### **Re: Permit Application No. P24863**

I refer to the above application for the proposed development of the D Division exercise yards (part) and adjacent land to the south and east. Outlined below are our concerns in relation to this proposal.

Figure 1: Ronald Bull Mural, F Division (Michael Hamel Green, inspected 12 November 2015)

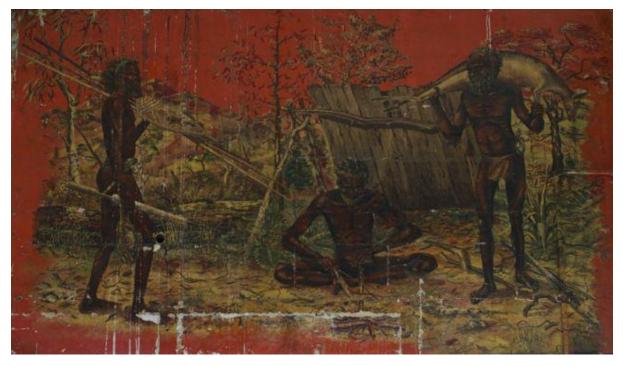
The Trust is concerned about reports by members of the local community who have recently inspected the Ronald Bull Mural in F Division that it is deteriorating and requires attention from a conservator. The National Trust therefore requests that Heritage Victoria **urgently** seeks an undertaking from Future Estate to fulfil their obligations to conserve this important mural before it deteriorates any further. It is our understanding that the mural is also on the Victorian Aboriginal Heritage Register. Work should therefore be undertaken in accordance with the *Aboriginal Heritage Act 2006* and in consultation with appropriate Aboriginal stakeholders, including the Office of Aboriginal Victoria.
